Revised proposal for amendments regarding ECE/TRANS/WP.29/2022/59

Modifications to ECE/TRANS/WP.29/2022/59 are in **bold** for new or ~~strikethrough~~ for deleted characters.

Model A

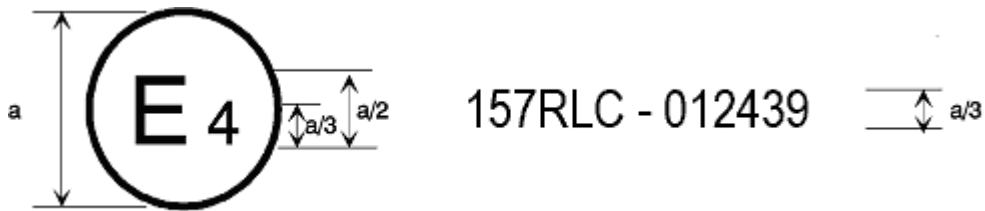
The above approval mark affixed to a vehicle shows that the vehicle type concerned has, with regard to ALKS, been approved in the Netherlands (E 4) pursuant to UN Regulation No. 157 under approval No. ~~002439~~ **012439 and is capable of a lane change procedure**. The approval number indicates that the approval was granted in accordance with the requirements of UN Regulation No. 157 ~~in its original version~~ **with the 01 series of amendments incorporated**.

Model B

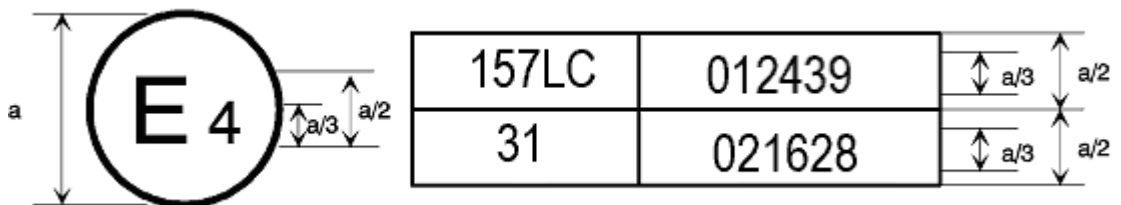
The above approval mark affixed to a vehicle shows that the vehicle type concerned has been approved in the Netherlands (E 4) pursuant to Regulations Nos. 157 (**capable of a lane change procedure**) and 31.¹ The approval numbers indicate that, at the dates when the respective approvals were given, UN Regulation No. 157 ~~was in its original version~~ **included the 01 series of amendments** and UN Regulation No. 31 included the 02 series of amendments.
